## L4452A-01

# S E R V I C E N O T E

## L4452A Multifunction Module with DIO, D/A, and Totalizer

Instrument cannot operate in 400 Hz

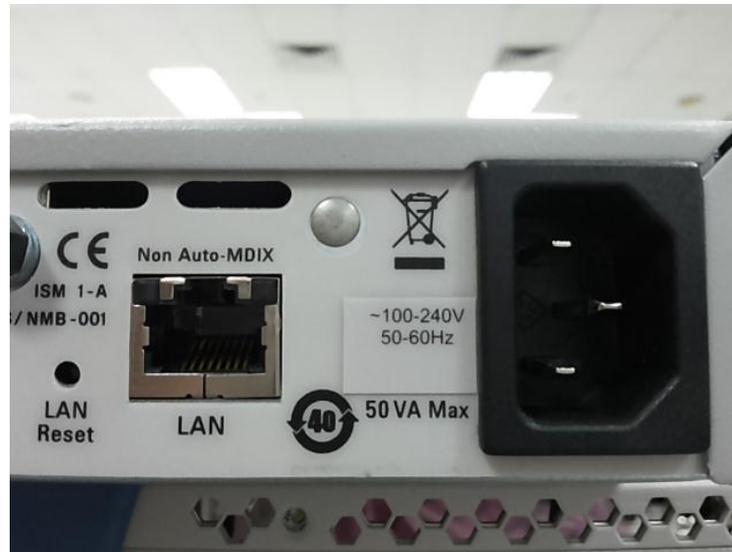
It has been found that the instruments with affected serial numbers listed above have incorrect information printed on the power rating label. The instrument does NOT support 400 Hz operation at 100-127V.

Order a L4421-84303 L44xxA Power Rating Label and apply it over the existing power rating information on the instrument. After applying the L4421-84303 label, it should look similar to the picture below.
